ADDENDUM NUMBER 3

Bid 31-24

Proposed Repair of Maplewood Avenue Bridge over North Mill Pond

Issued February 27, 2024

Figure 1: Excerpt from record drawings of North Mill Pond Bridge and Sewer Line dated March 1976

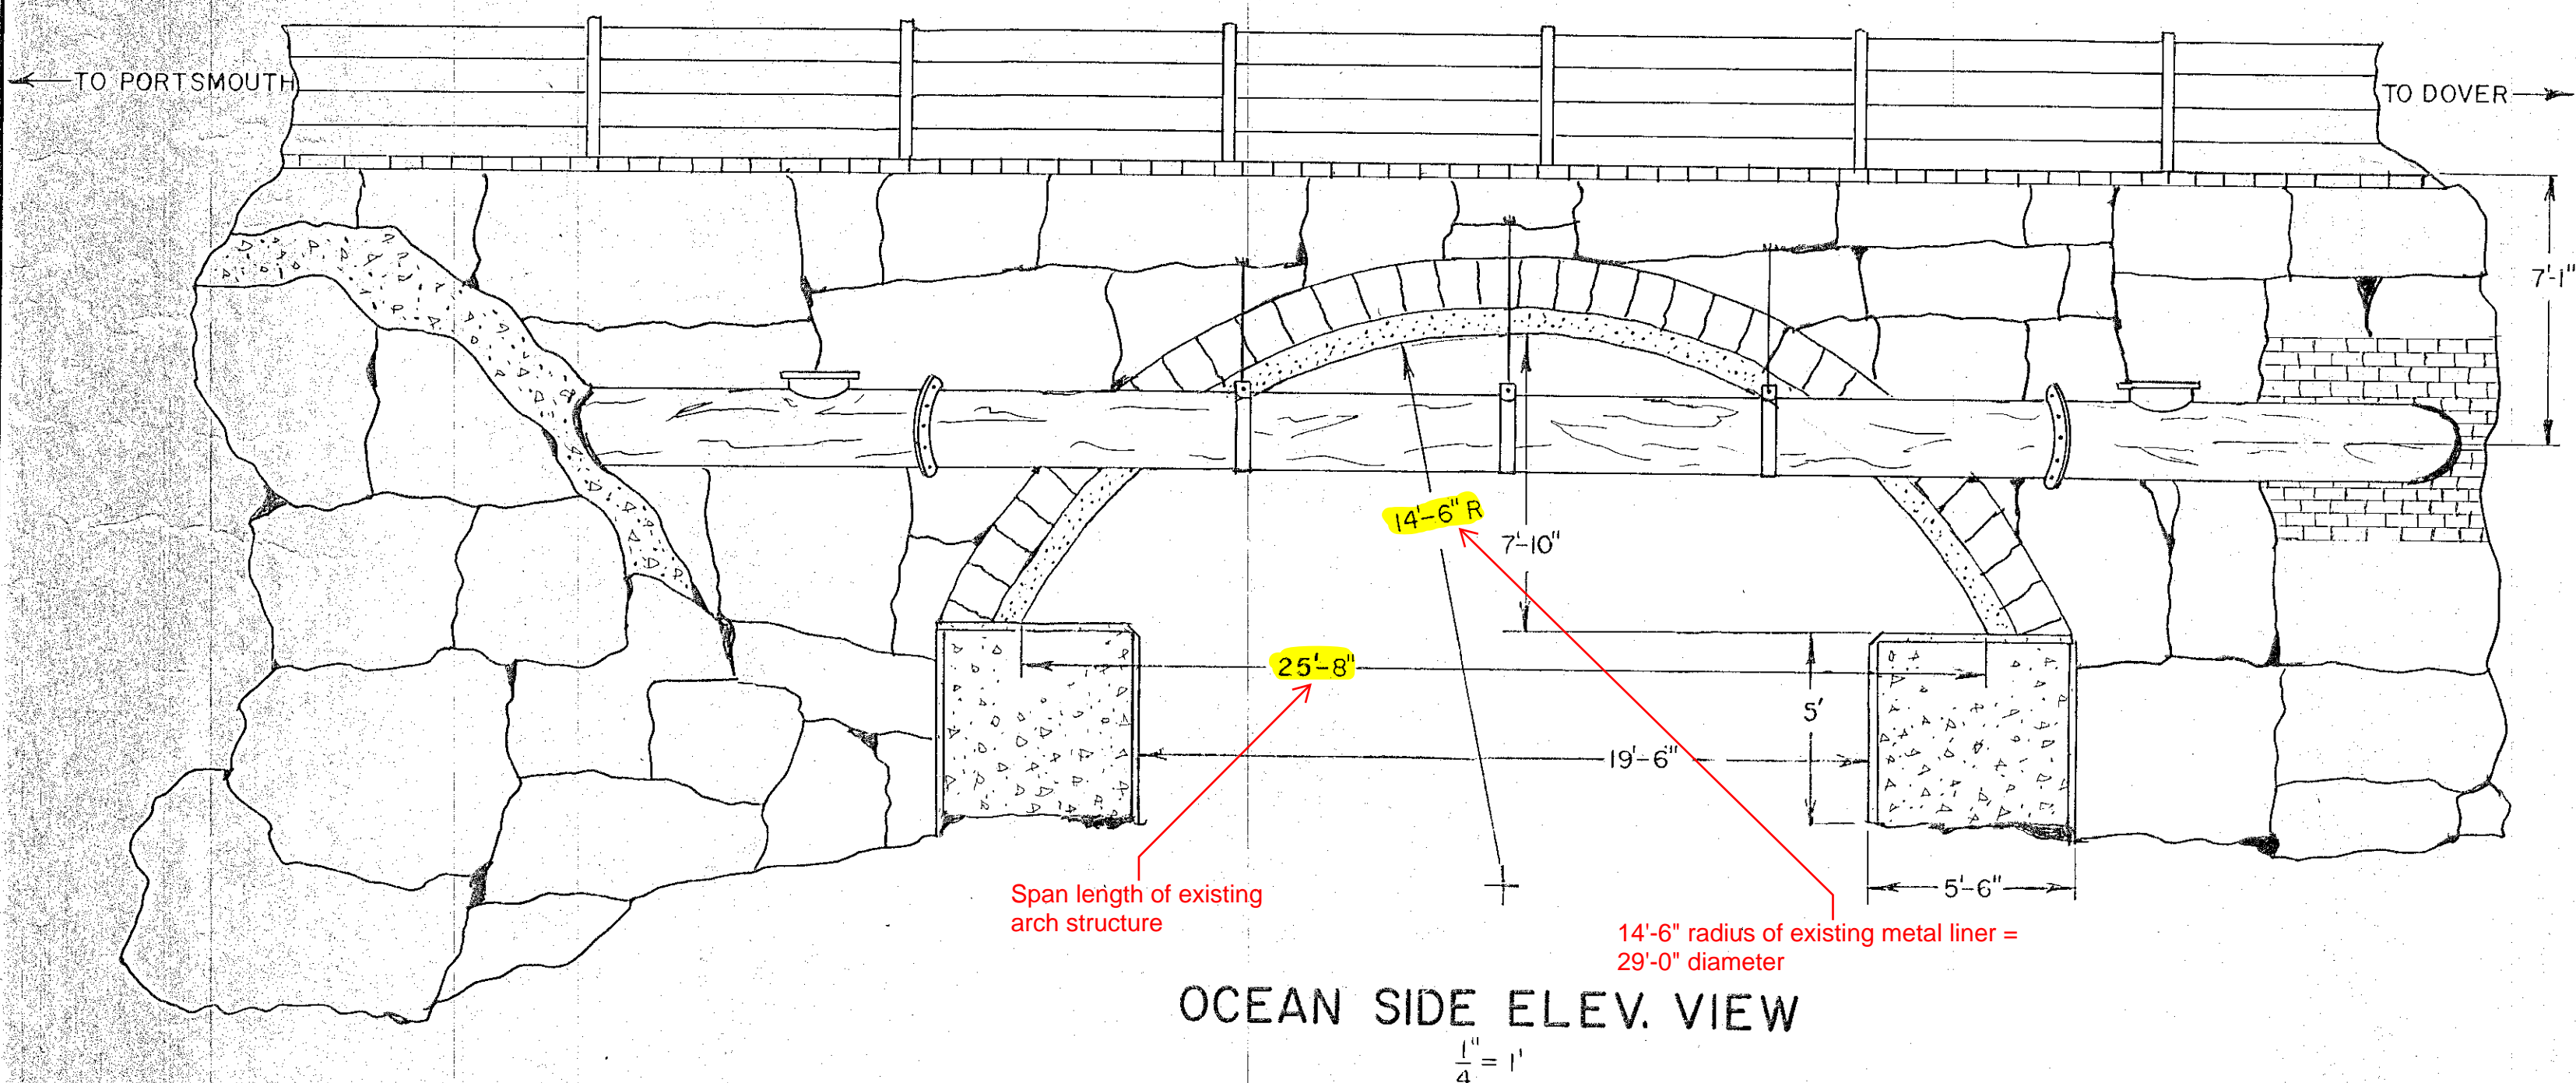
Here is RFI #9 which is a follow up question to your Addendum TWO RFI no 8 & 3 Q&A. The RFI no 8 response essentially stated that “preliminary coordination with one geopolymer installer (during the design phase) indicates that the specified maximum thickness of 4.5” is sufficient” (ie 4.5” should work as both A. a stand alone liner design thickness calculation and B. also pass the load rating requirements of NHDOT.) Also the RFI 3 response stated that the geometry to use for the liner design is 29’ diameter and a minimum of 3’9”. Since you are basing this entire project on somebody else’s design, can you please provide the moment design equation that the load rating calculation is based on, and please confirm all initial designs were based on the 29’ diameter and 3’9” min cover. I suspect the span of 25’8” may of been used rather than 29’ diameter, or a cover deeper than 3’9” may of been used. Or just a liner thickness calc was done but not a load rating calc. We would propose to use GeoSpray geopolymer material which is significantly stronger at 1500 psi min flexural strength compared to the only other approved GeoKrete geopolymer of 800 psi flexural strength. At this point in time, we can not get the Federal Load bearing calculation to pass at 4.5” so this is a red flag.

The moment design equation that the preliminary load rating calculation was based on is not available. However, initial designs were based on an arch with span length of 25’-8”, a radius of 14’-6” (29’ diameter), and 3’-9” minimum cover. The detail in Figure 1 of this addendum is taken from the Record Drawings from the 1976 lining project which are included in the Contract Documents as Appendix A.
